Distr.: General
Date: 9 November 2020

Economic Commission for Europe**Inland Transport Committee****World Forum for Harmonization of Vehicle Regulations****Working Party on Noise and Tyres****Seventy-third session**

Tyres: UN Regulation No. 109 (Retreaded tyres for commercial vehicles and their trailers)**Proposal for amendments to UN Regulation No. 109****Submitted by the experts from the Bureau International Permanent des Associations de Vendeurs et Rechapeurs de Pneumatiques (BIPAVÉR)***

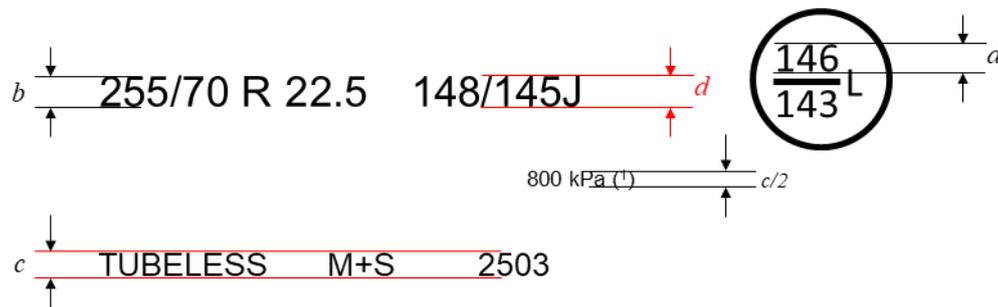
Insert a new paragraph 12.3., to read:

- 12.3. Until 1 September 2024, Contracting Parties applying this Regulation may continue to grant type approvals according to the 02 series of amendments to this Regulation, based on snow performance test described in Annex 7 to this Regulation using SRTT14 as reference tyre. ^(a)**

"Example 1:

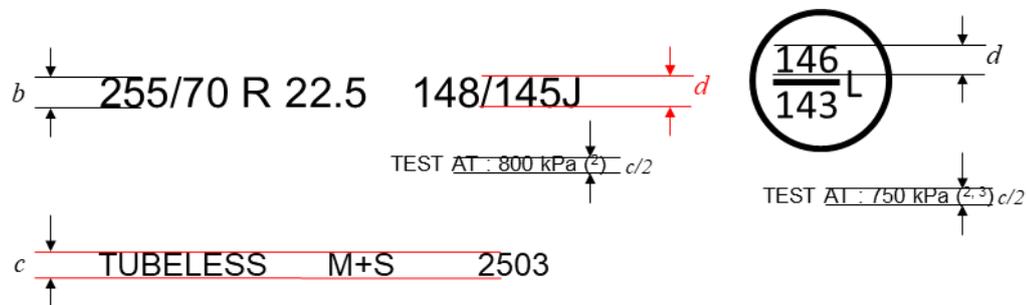
Annex 3,

Figure, replace and amend to read:

- (1) PSI marking instead of kPa is allowed for tyres first type approved before 1 January 2018. The kPa marking may be preceded by "TEST AT : " or, alternatively, by "TEST INFL : " or the symbol "@".
